Date: June 6, 1979

Re: Gabriola Island Community Plan, Fault Zones

As requested by Mr. G. Tonn, Planner with the Islands Trust, a review has been undertaken of available hydrogeologic information pertaining to four "fault zones" designated in the map accompanying the Gabriola Island Community Plan (1978). These linear zones (700-foot wide strip) have been included in the community plan under Resource Protection Areas (20-acre minimum lot size), as "linear areas of rock fracture which allow surface and sub-surface water to penetrate to underground water sources known as aquifers". Available well log data, existing geology and groundwater reports and air photographs were examined in conjunction with a field visit of the area on May 30, 1979 to assess the hydrologic significance of these "fault" designated zones. For purposes of discussion the four linear zones have been arbitrarily designated areas A, B, C and D (Figure 1). A brief description of each zone is given below following a general discussion on fault terminology.

FIGURE 1.

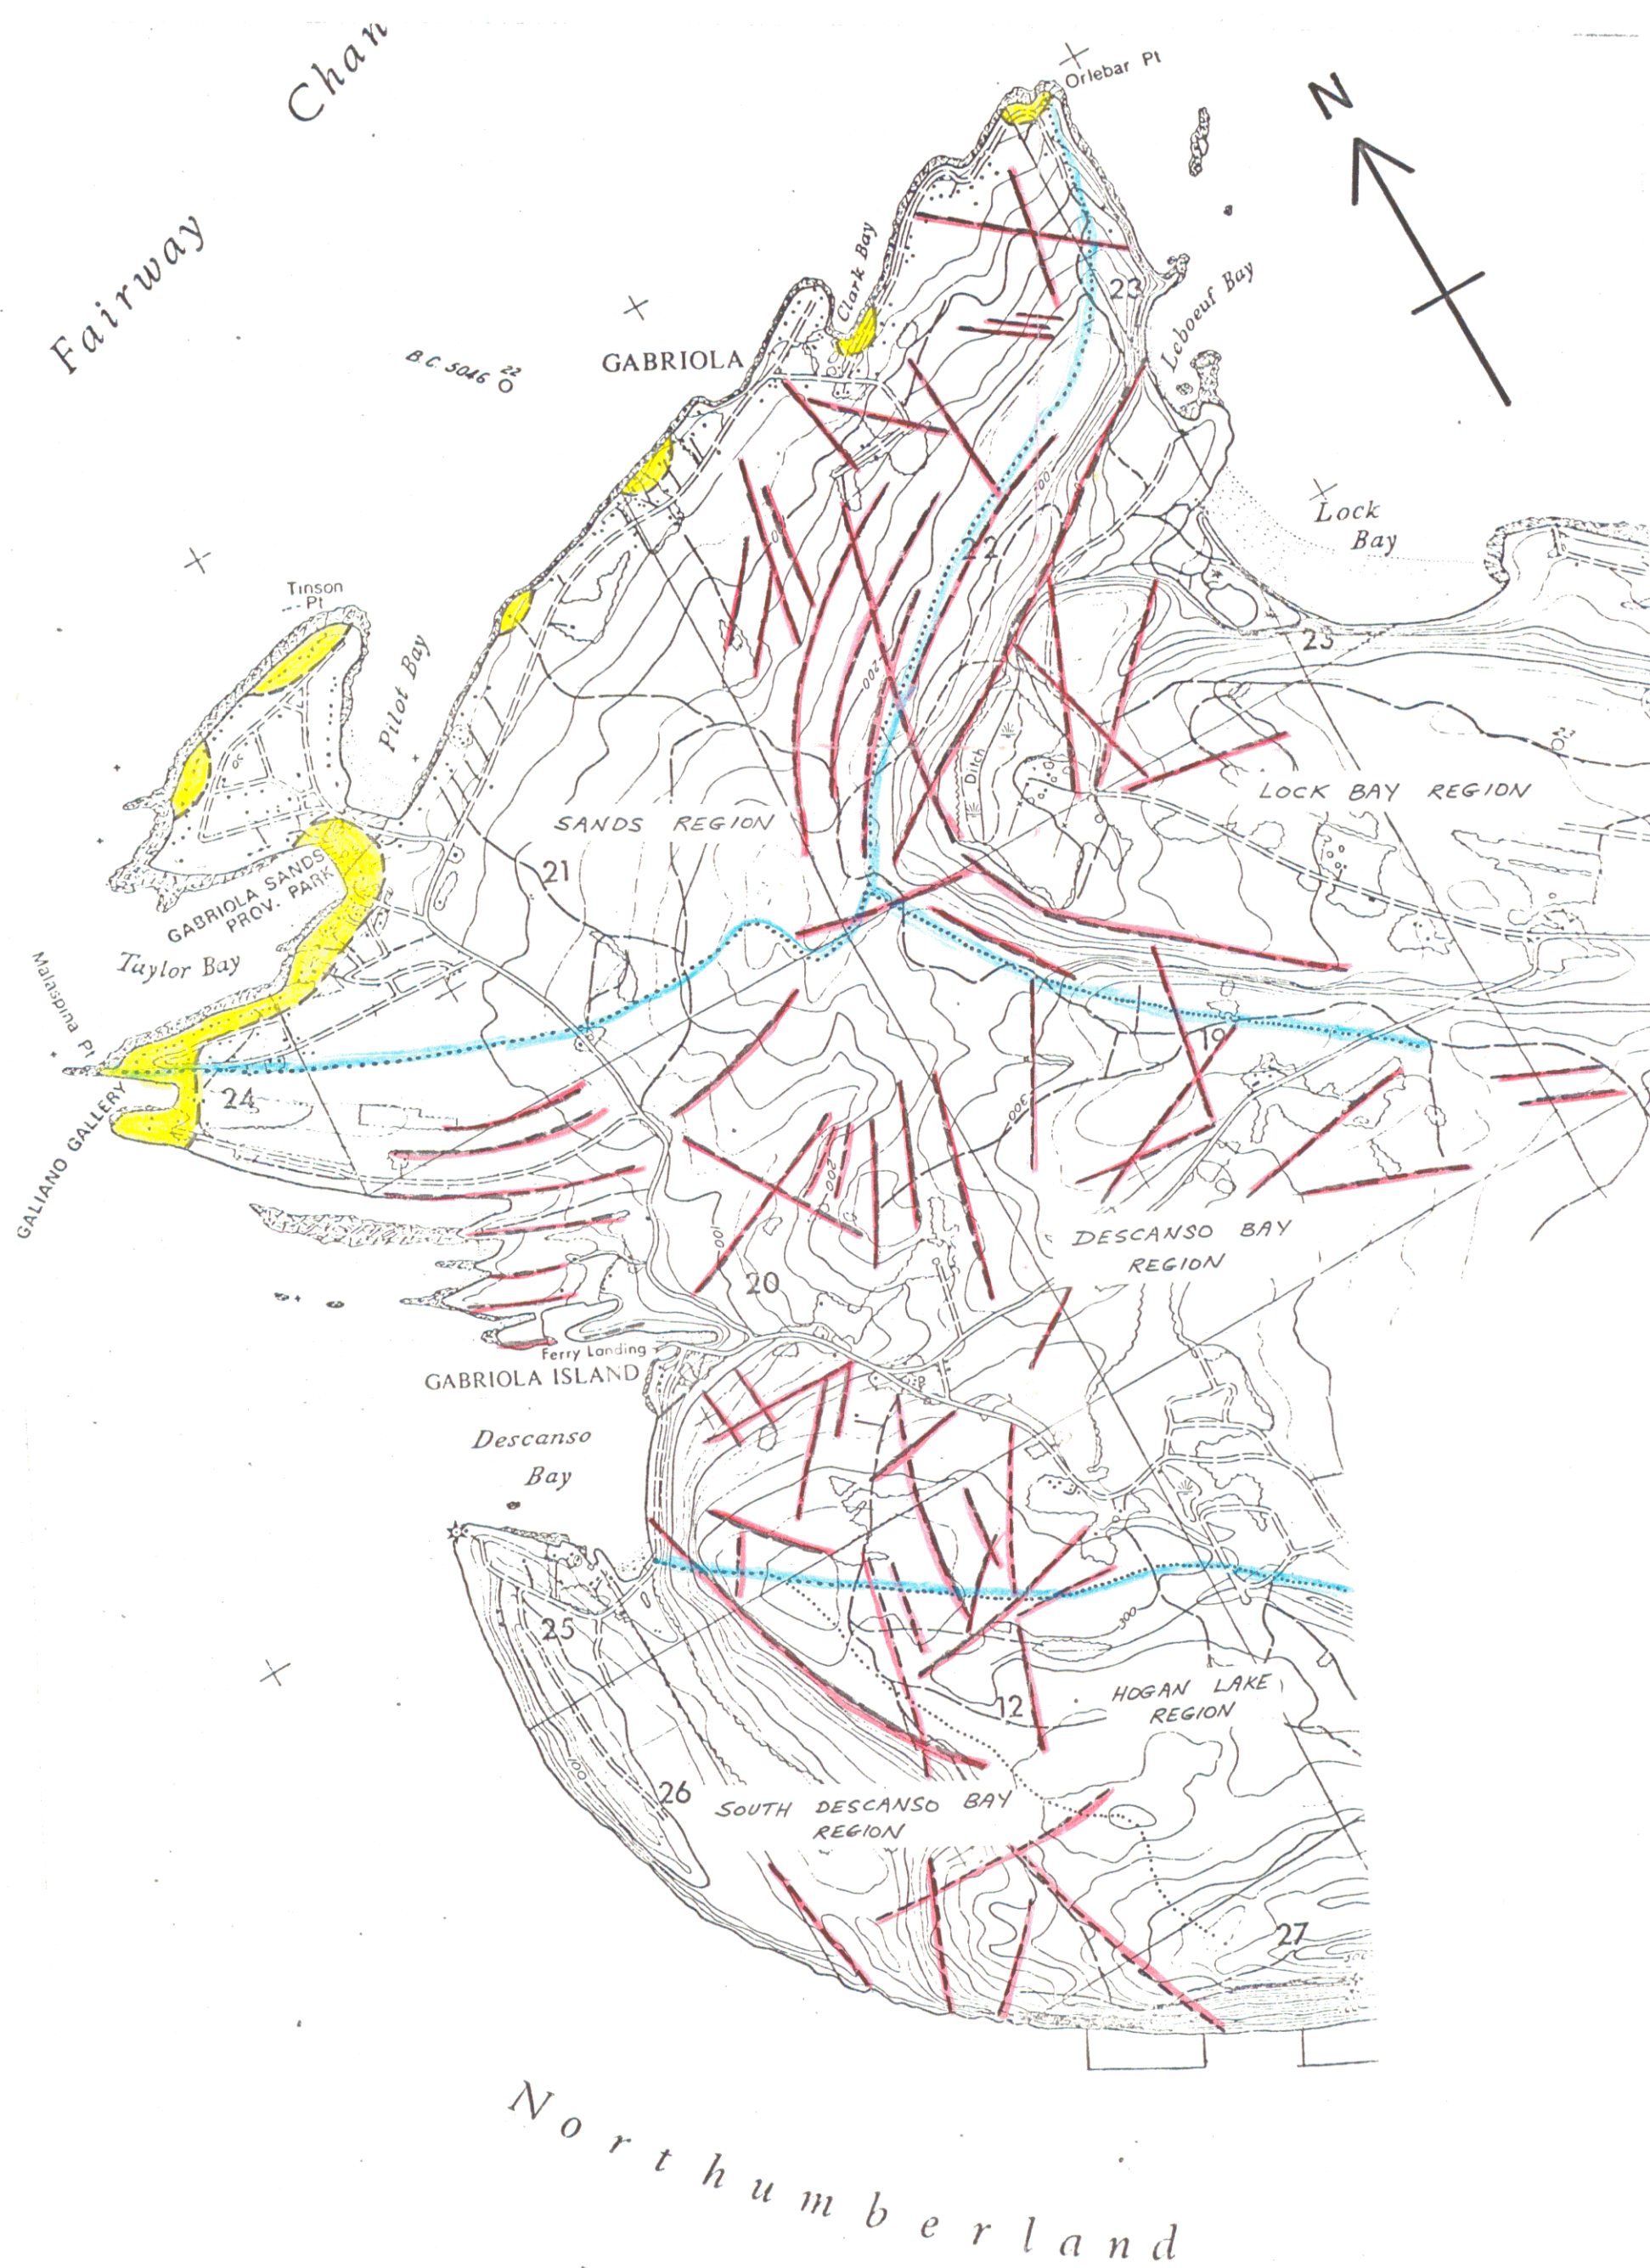
This east-west trending zone (Figure 1) lies within a major valley trend, paralleling North Road. Muller and Jeletzky (1970) indicate a major fault occurring along this trend. Several domestic wells have been drilled on properties adjacent to North Road and for the most part well yields are low. Some wells up to 212 feet deep in Section 20 adjacent to the fault zone have been reported dry. In Section 19 there is some evidence of good capacity from a deep well (greater than 200 feet in depth) on the north side of the valley. The areal distribution of water levels in existing wells suggests that groundwater recharge is taking place on the upland areas adjacent to the valley and in the upper portions of the watershed and groundwater flow is into the main valley and westerly down the topographic gradient. Local springs are evident in the valley in Section 20. In Section 19 the upper reaches of the valley above elevation 300 feet and underlain by the fault zone may be an important area of groundwater recharge, providing the fault zone is relatively permeable.

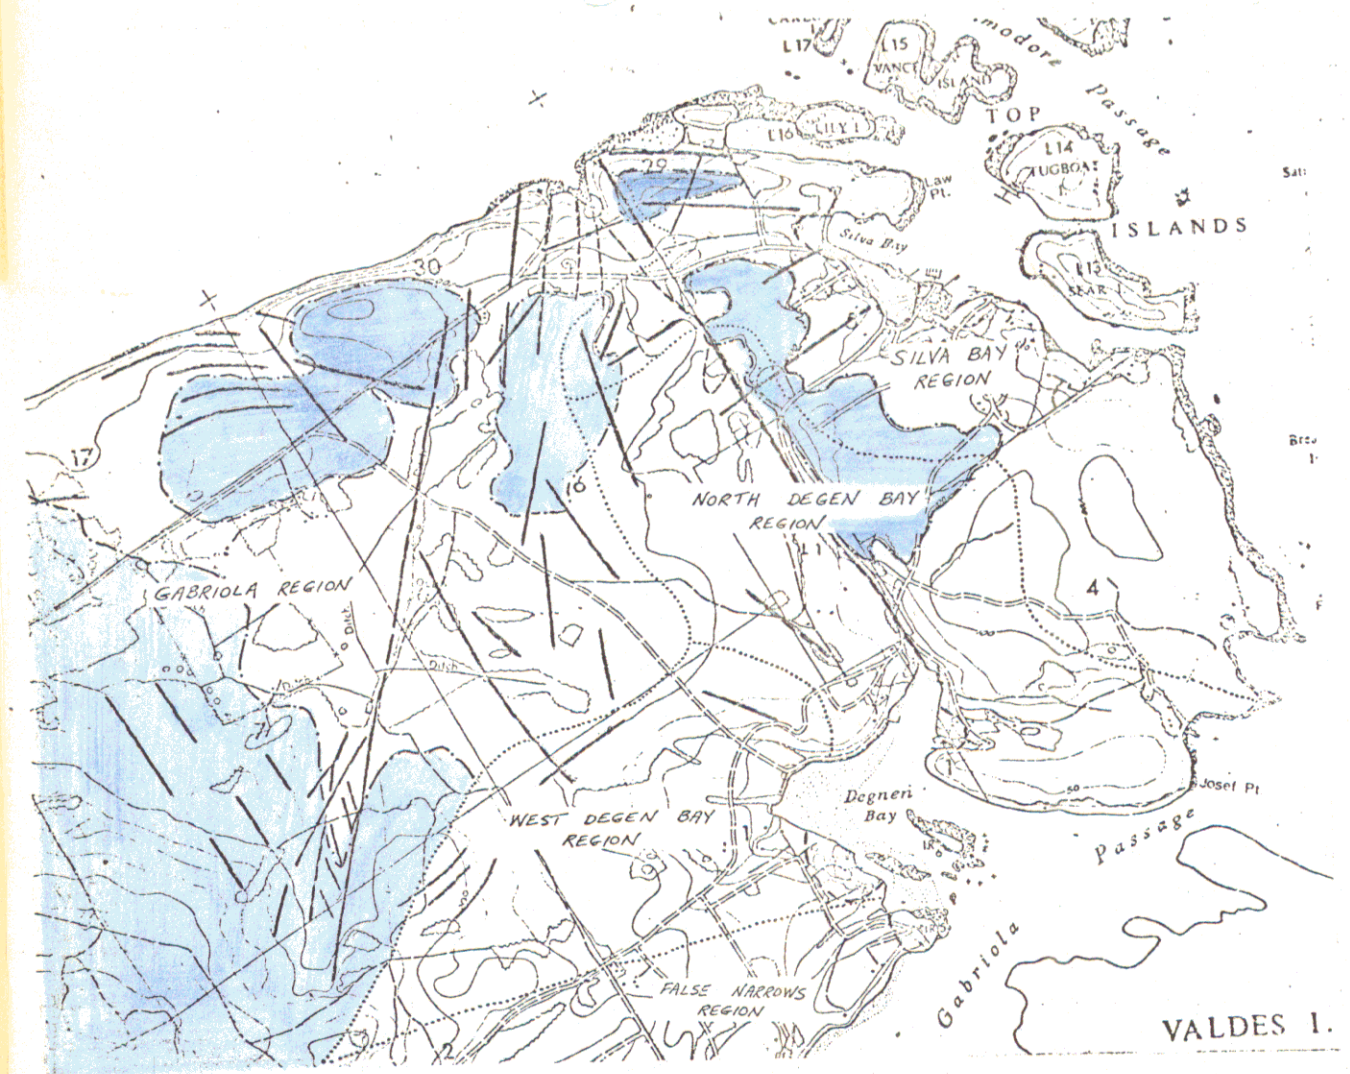
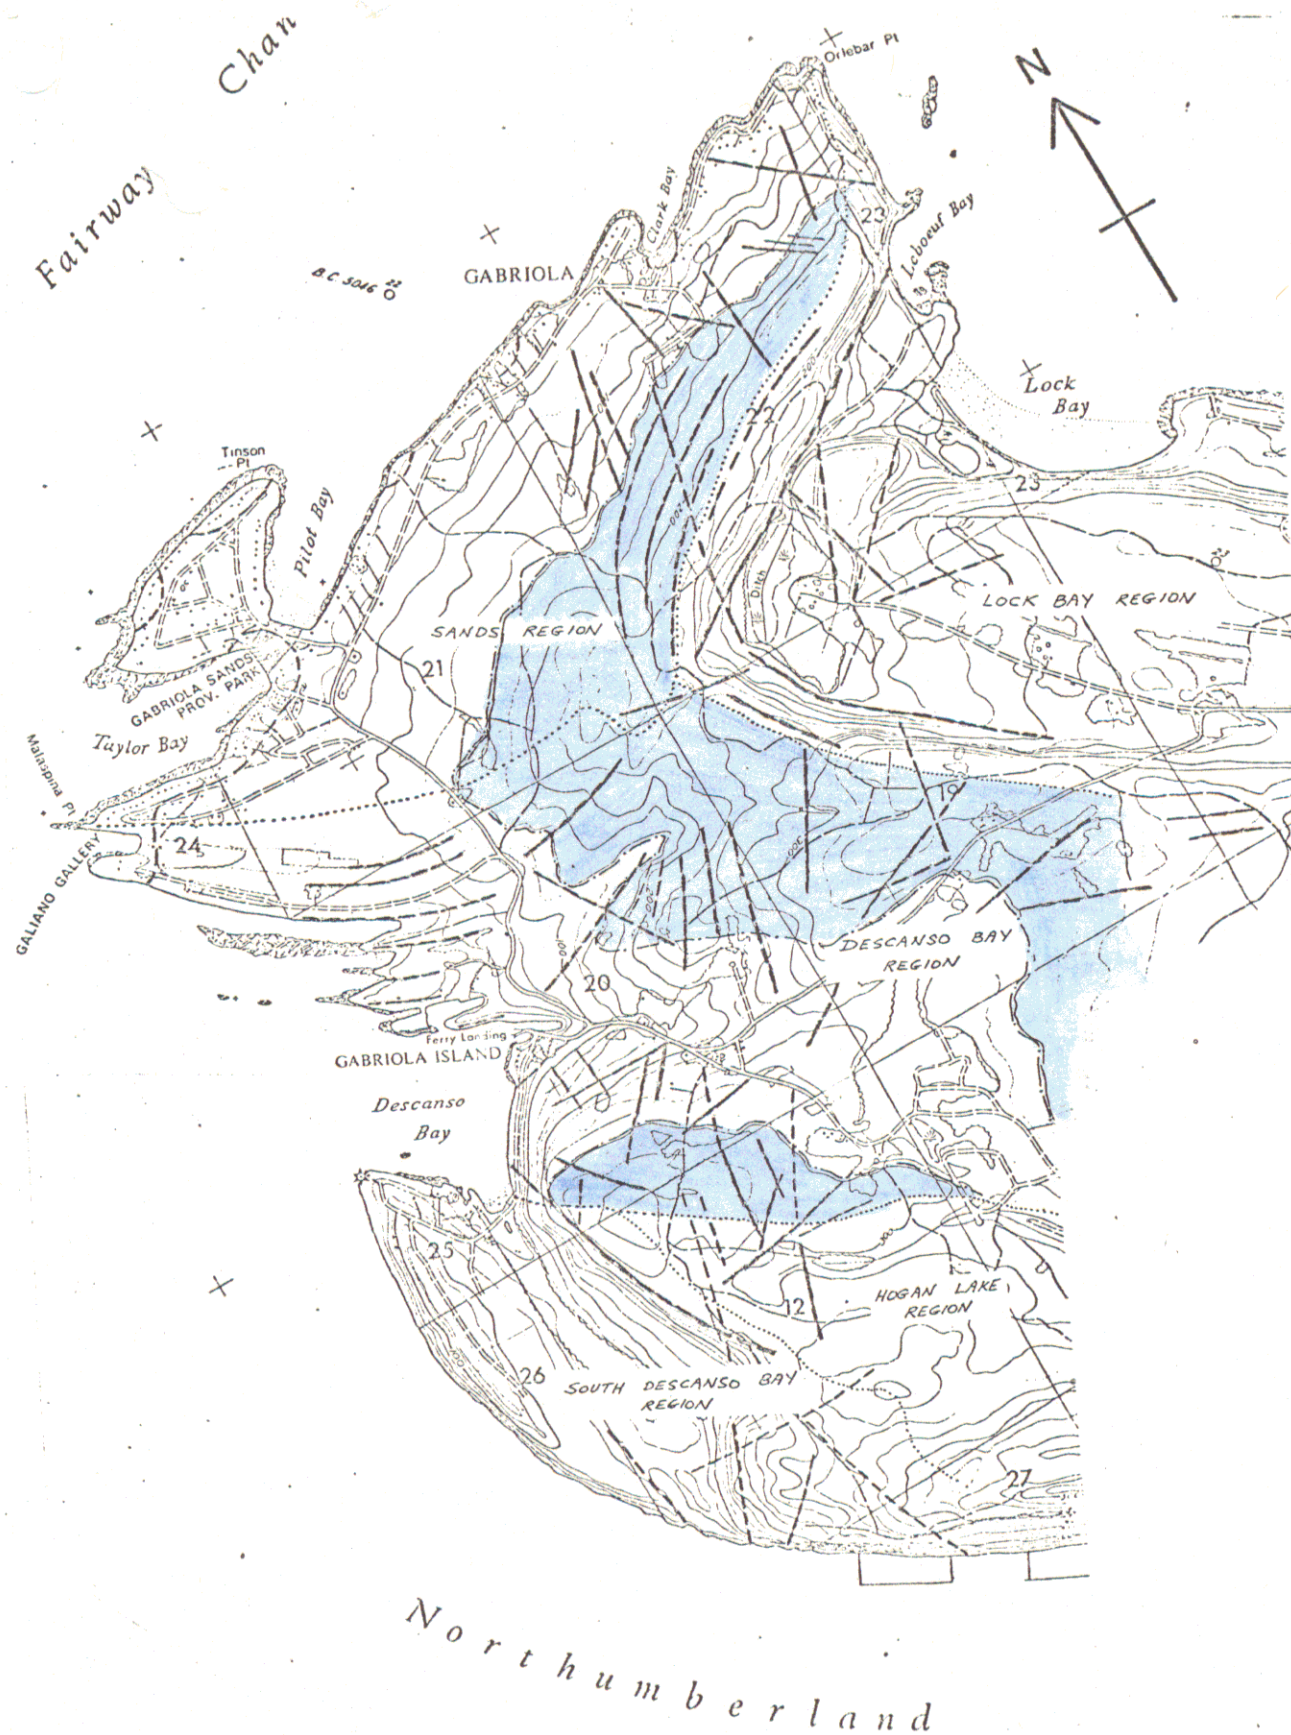
fault zone into the Descanso Bay area. From air photograph analysis there are on the other hand numerous structural lineaments evident in the area (Figure 2). These for the most part reflect bedding planes (curved lineaments) and traces of joints the latter of which southwest to northeast and northwest to southeast trending sets are predominant. There is no hydrogeologic evidence for differentiating the Resource Protection Area in the northeast portion of Section 20 from adjacent Rural designated areas (10-acre minimum lot size).

This northeasterly striking zone forms the northern extension of a major structural lineament clearly evident in air photographs of the island. The lineament has been mapped as a major transverse fault by Muller and Jeletzky (1970). In the northeastern part of Section 6 the zone occupies a topographic low (saddle) between two ridges. A few shallow wells (less than 110 feet) have been completed in the zone, showing moderate well yields up to 5 gpm, with water levels ranging from 30 to 50 feet below ground surface. Flowing artesian conditions have been encountered north of the fault zone where it intersects Peterson Road. Where the fault zone intersects the coastline, several parallel embayments occupied by shear joints were observed during the field examination. These zones which parallel the fault trend do not appear particularly permeable (clay gouge observed on shear planes), although the zones are lithologically weaker and more susceptible to erosion than adjacent rock masses. Some saline groundwater having a specific conductance of 4 000 micromhos/cm and chloride concentration of 1 300 mg/L has been delineated along the coast near the fault zone (Figure 2).
